Nuclear Management Company, LLC
Point Beach Nuclear Plant
6610 Nuclear Road
Two Rivers, WI 54241

DOCKETS 50-266 AND 50-301
SUBMITTAL OF REVISION TO
PRESSURE TEMPERATURE LIMITS REPORT
POINT BEACH NUCLEAR PLANT, UNITS 1 AND 2

DESCRIPTION OF CHANGES
PRESSURE TEMPERATURE LIMITS REPORT
POINT BEACH NUCLEAR PLANT, UNITS 1 AND 2

REVISION 0

2.1.2 The RCS P-T limits for heatup and cooldown are specified by Figures 1 and 2, respectively (includes instrument uncertainty).

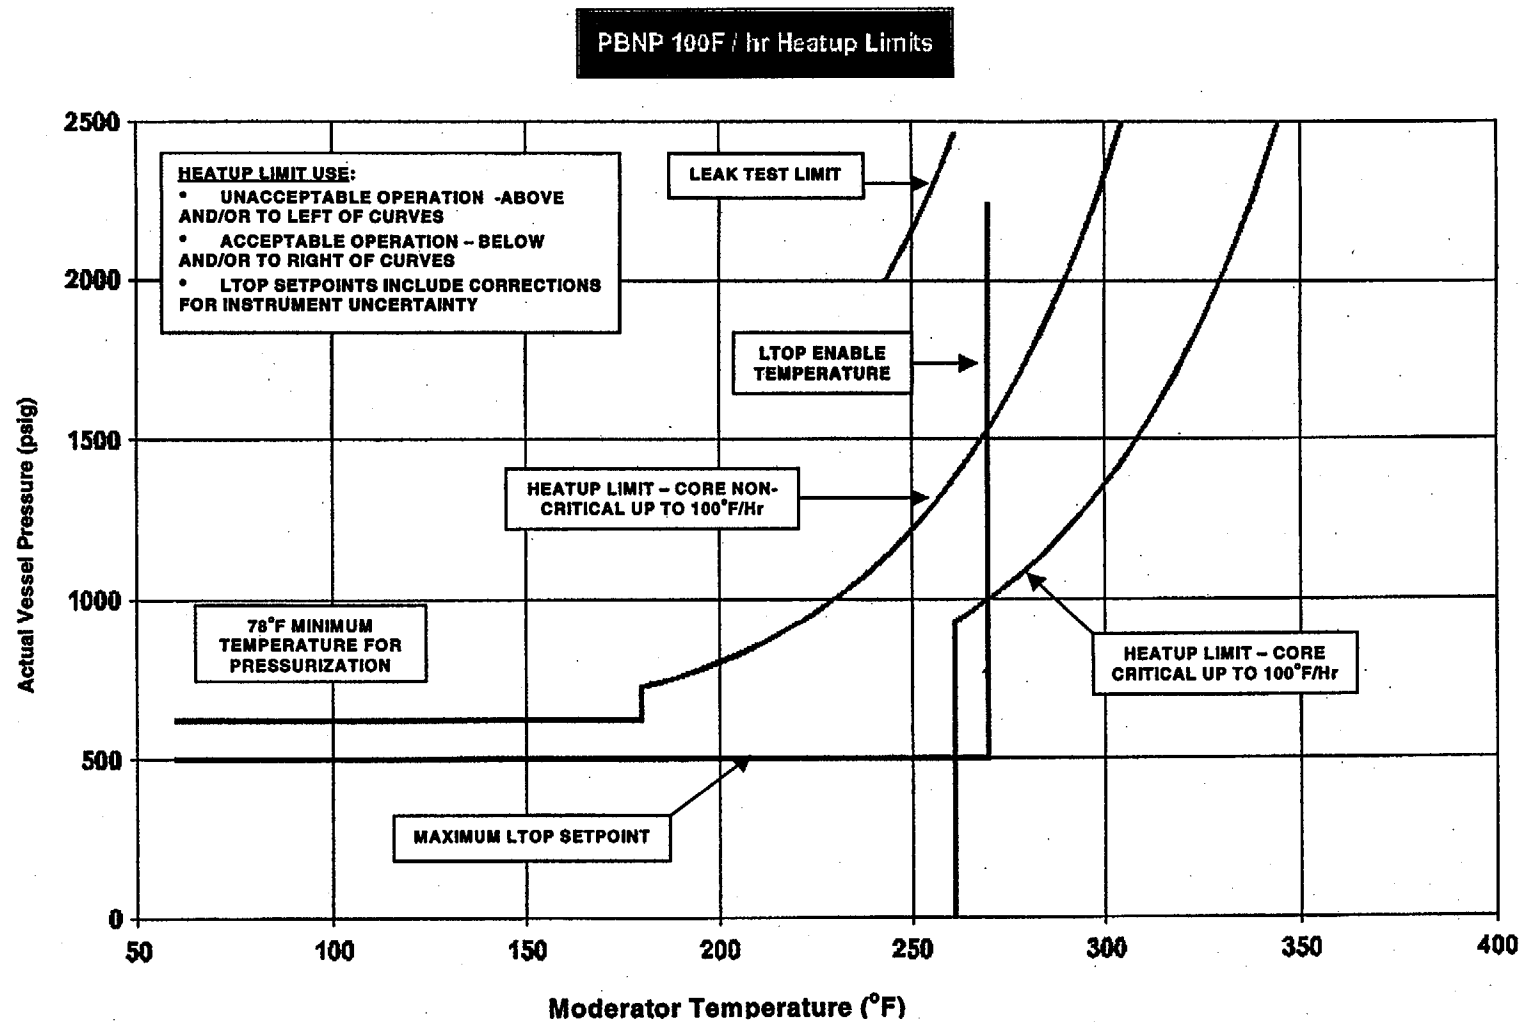
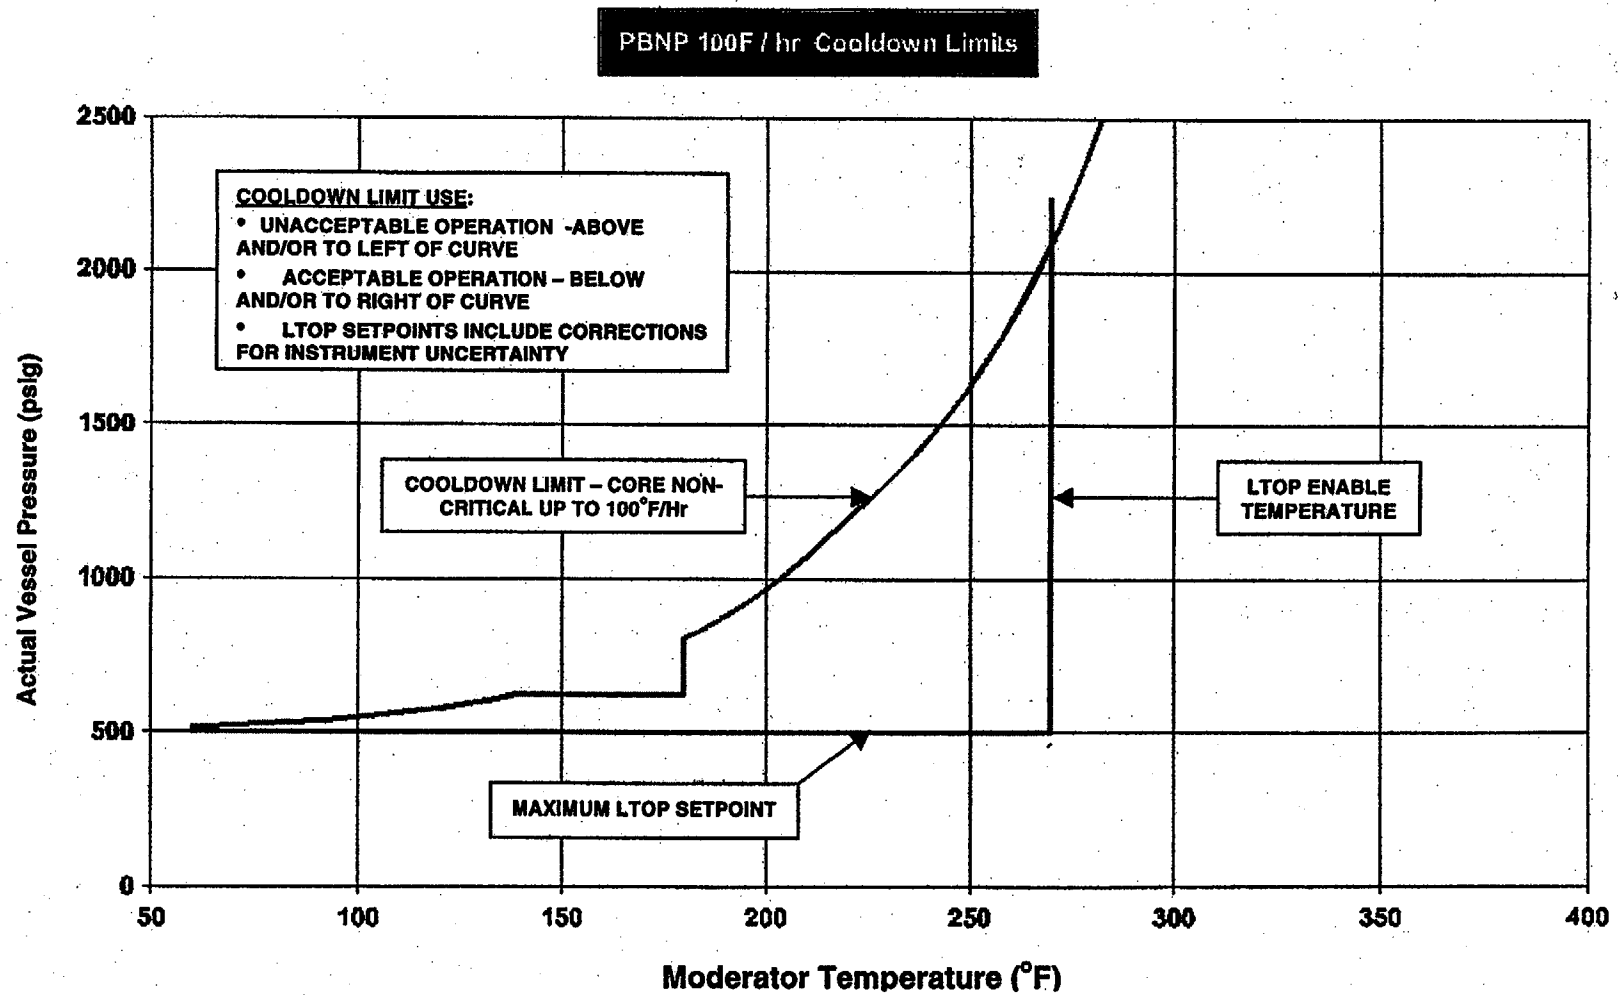
PTLR section 2.1.2 is clarified to specify that instrument uncertainty is included in the value specified for the limit. Section 2.1.3 is changed to reflect that the minimum temperature for

2.1.2 The RCS P-T limits for heatup and cooldown are specified by Figures 1 and 2, respectively (includes instrument uncertainty).
